TOWN OF NISKAYUNA
Planning Board and Zoning Commission

Agenda

August 29, 2022

MORGAN PROPERTIES MC CONVERSION: HILLCREST

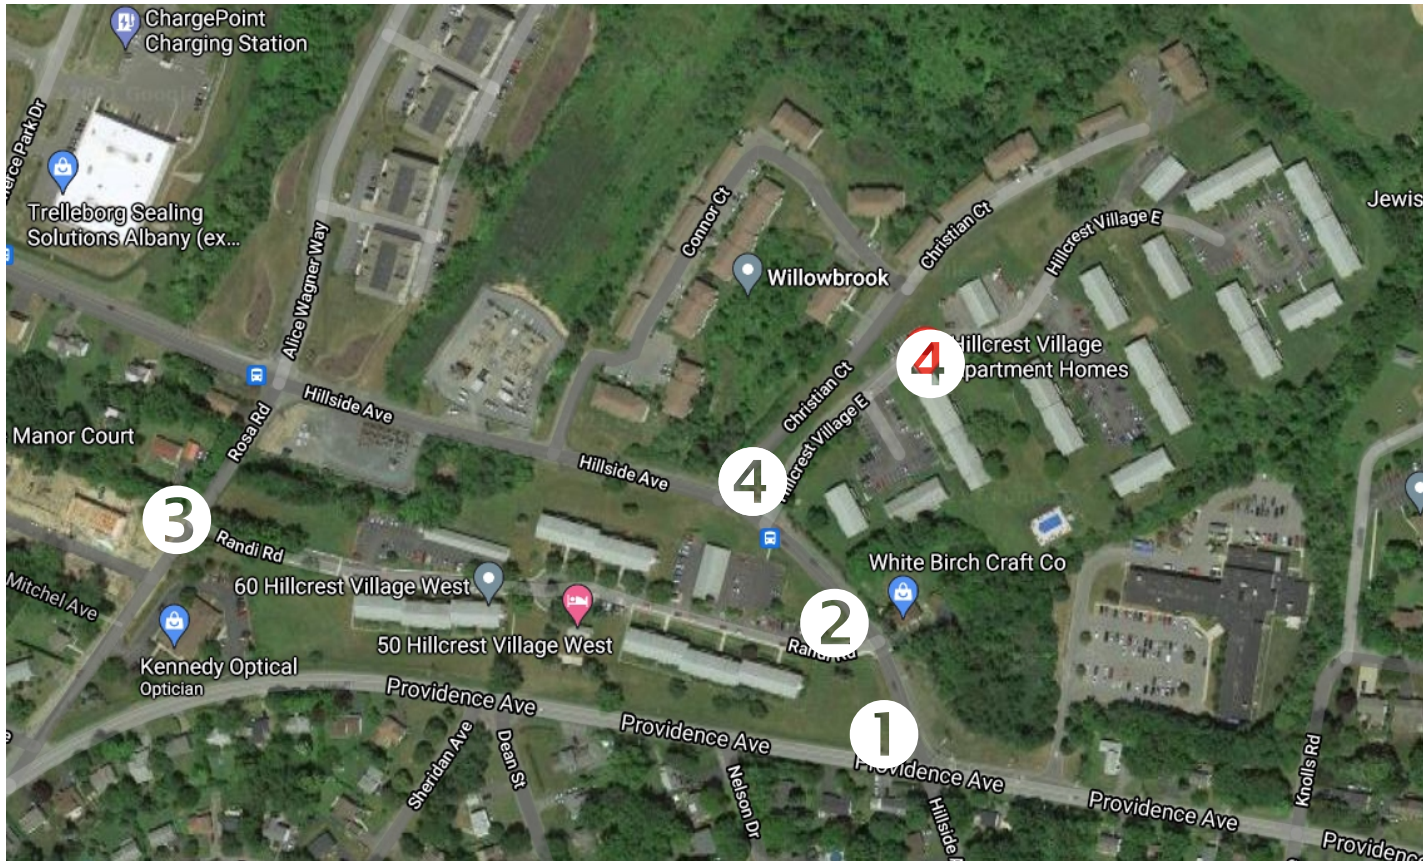
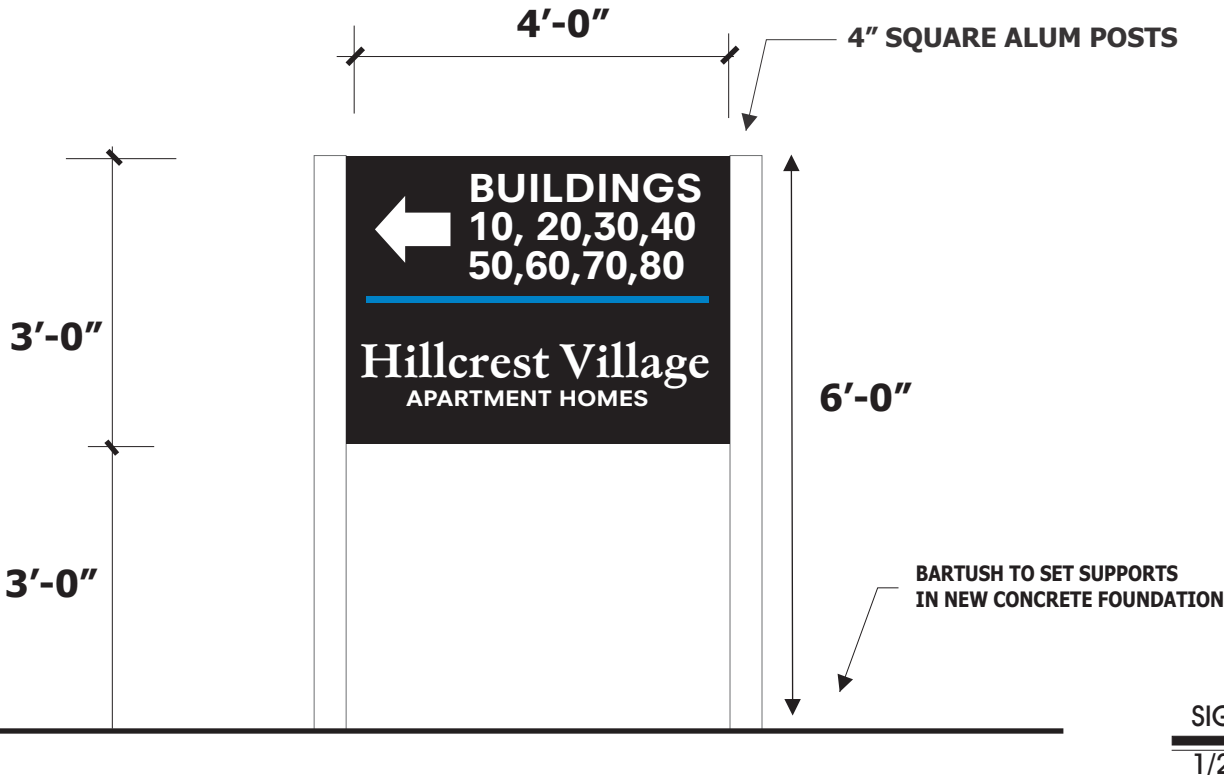
- Access point sign - replacement
- Replace existing 32sf panels with code conforming panels of the same size

- Access point sign – replacement
- Replace existing 13.8sf panels with code conforming panels of the same size

RESOLVED, that the Planning Board and Zoning Commission has determined that the proposed waiver for signage would have a minimum negative effect on aesthetics and is compatible with existing facades and does hereby grant said waiver as outlined above, and be it

REPLACEMENT SIGN:

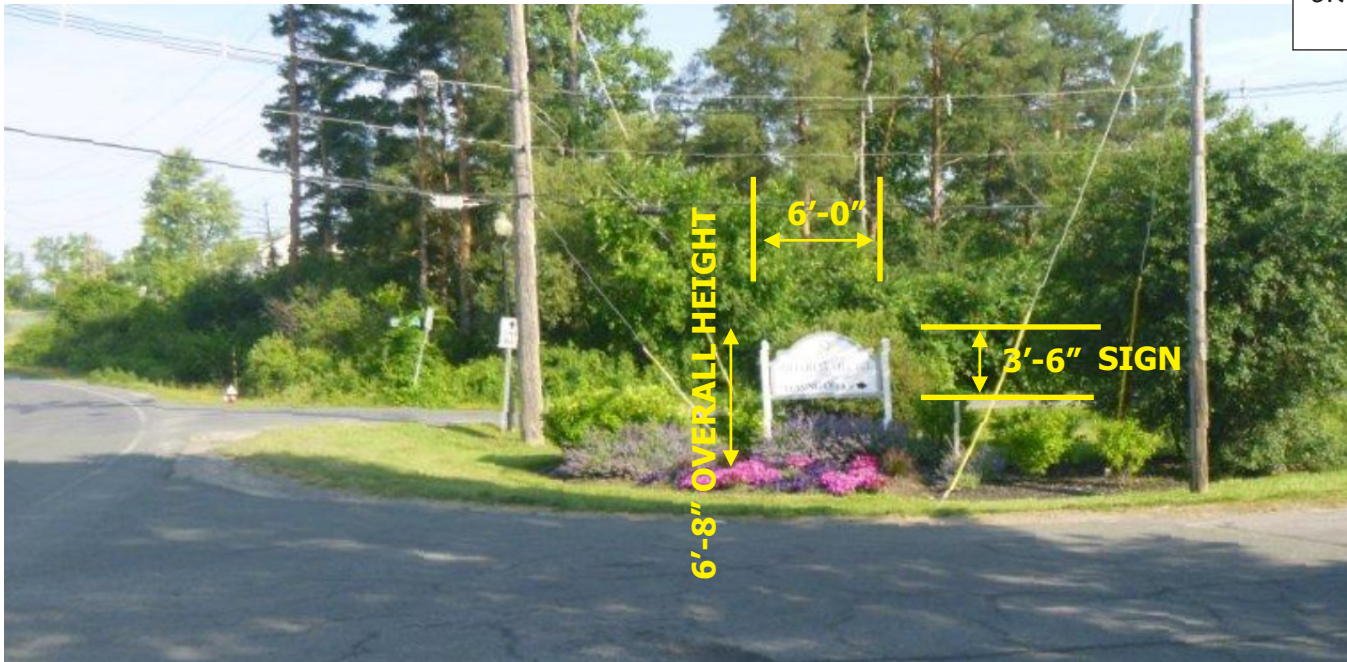
- Directional sign – replacement
- Replace existing 21sf directional sign with a new code conforming 20sf directional sign

SIGN 5 - LEASING CENTER ID SIGN

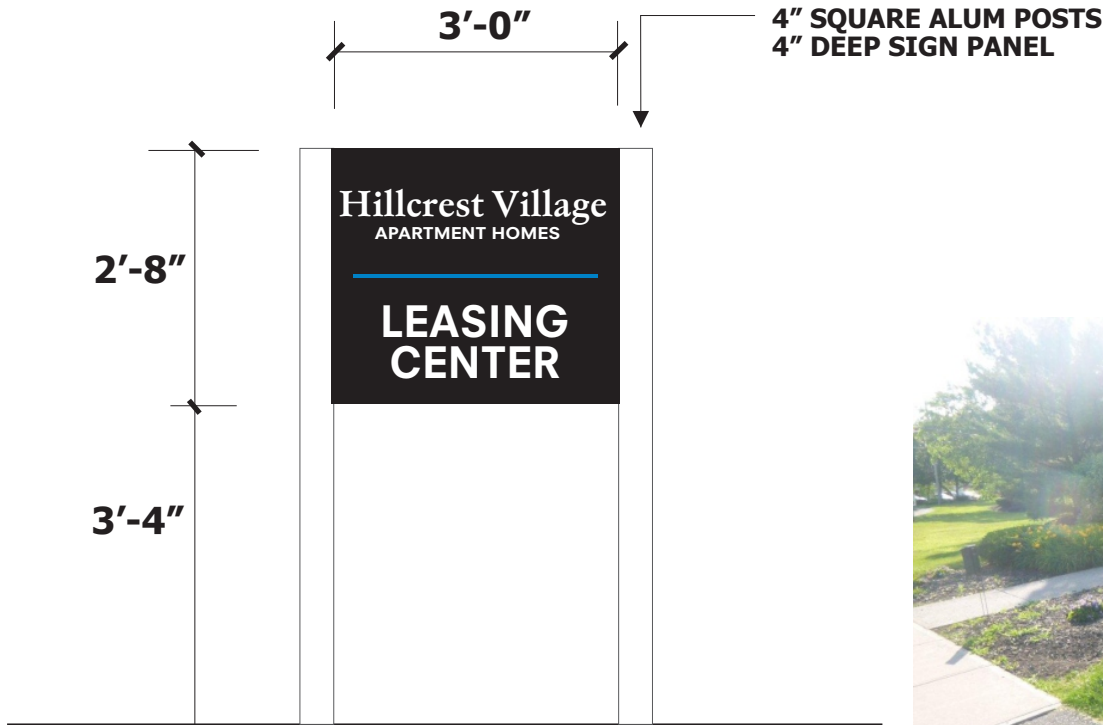
- Directional sign – replacement
- Replace existing 5.25sf sign with a new 8sf sign
- Section 220-26 J Signs states “....any number of directional signs, each not to exceed four square feet in area and eight feet above average grade, may be permitted.”
- As proposed, the new directional sign measures 8sf in area and is 6’ high
- *Therefore, a waiver of 4sf of directional sign area is needed*

REMOVE & REPLACE THIS
SIGN - EXISTING
SIGN IS 21" X 36" = 5.25 SF
